CPUC Docket: A.16-09-001

Exhibit: TURN-06

**PREPARED TESTIMONY OF
PAUL ALVAREZ AND DENNIS STEPHENS**

**TESTIMONY REGARDING SCE GRC T&D Chapter, Volumes
3) System Planning; 6) Substation Construction and Maintenance; and
10) Grid Modernization (DER-related Components)**

1 *Figure 1: "Response Time Improvements from DA and GMS"*

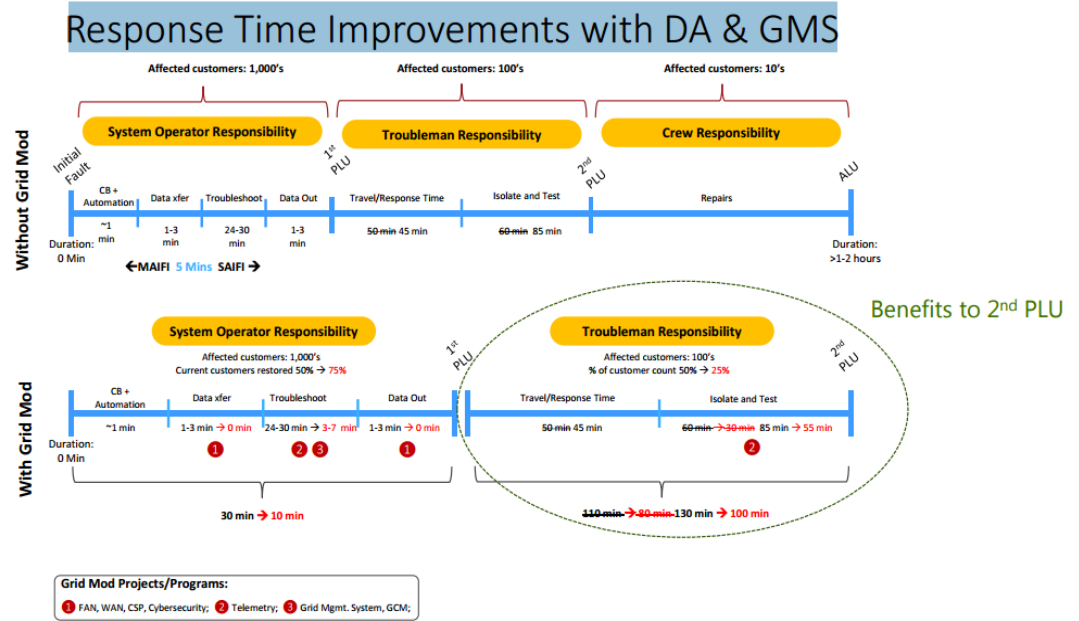
2
3 The “System Operators Responsibility” area of this diagram indicates an improvement of
4 20 minutes using Telemetry and GMS over the traditional method of Trouble Shooting. I
5 will show that this savings is not due to advanced equipment telemetry or due to GMS.

Figure 2: Traditional Fault Indicator vs. Remote Fault Indicator Benefits

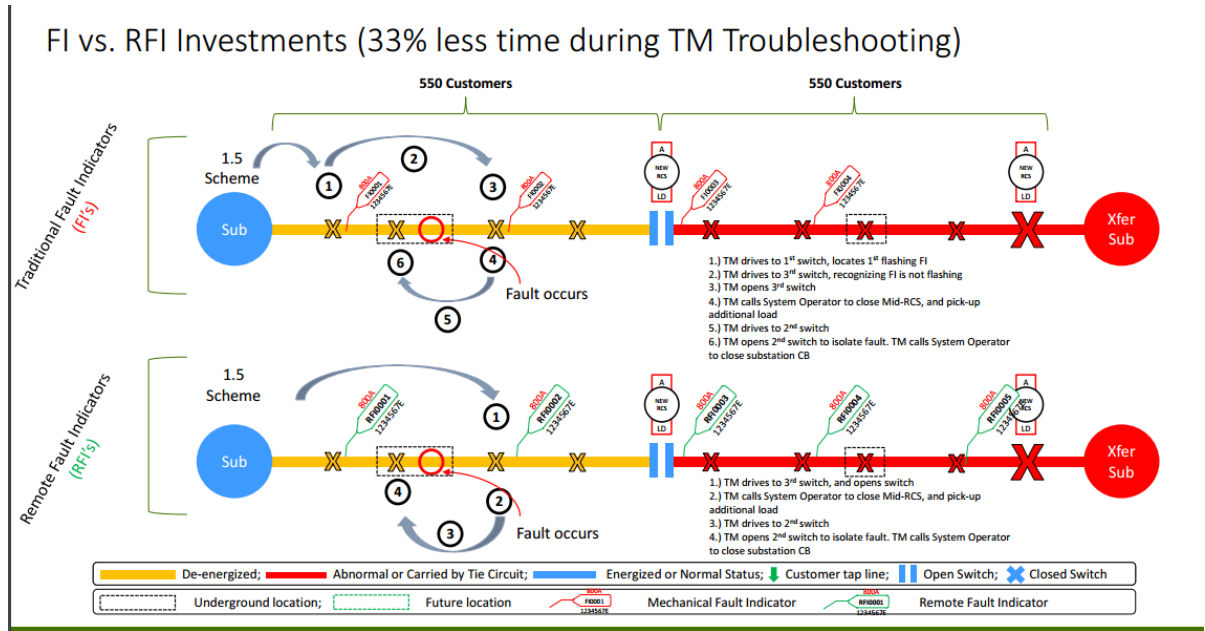
6
7 In the problem analysis pages starting on page 6 of this document, the Company describes
8 its proposal to replace traditional fault indicators, which must be observed visually in the
9 field, with remote fault indicators, or RFIs, which can report data over the NetComm
10 network back to grid operators.
